Addendum 2: RFP No. 32003560-01 Last Questions and Answers Issued August 22, 2025

Community Solar Project

EV Charging Stations Project

FIGURE 1

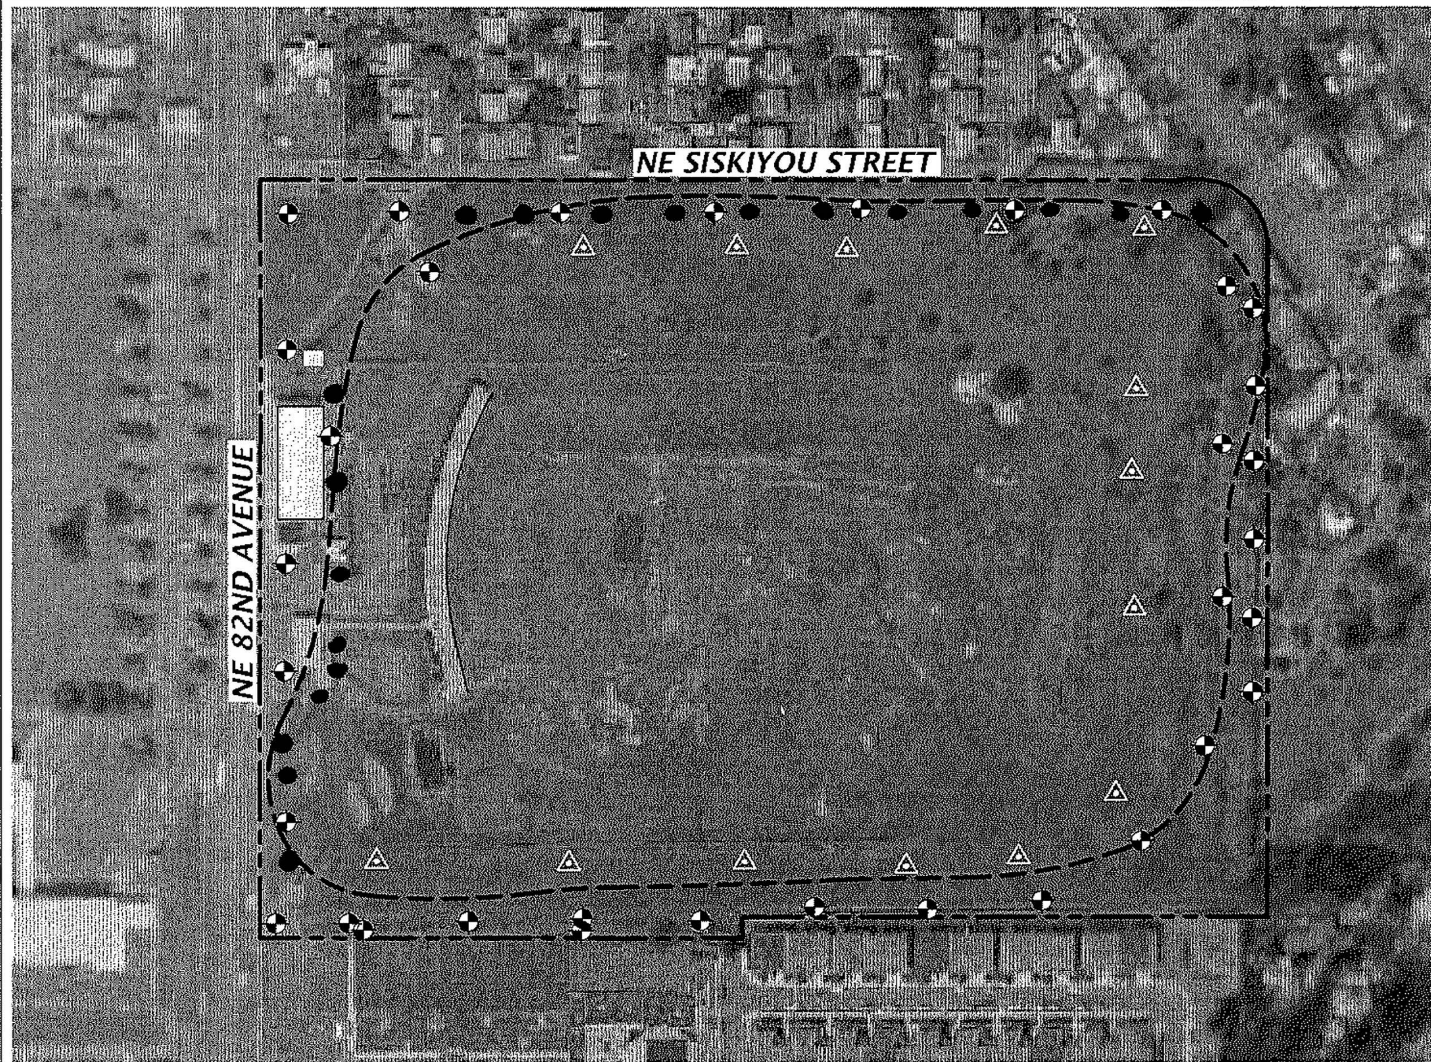
4. Clarification on where the landfill cap is and where we can disturb the soil.
 - a. See Appendix A: Map of Approximate Extent of Landfill Cap, on the last page of this Addendum. Please note the DEQ basis of design requirements on disturbing soil ([Addendum 1: Community Solar Site Reports, Basis of Design](#)).
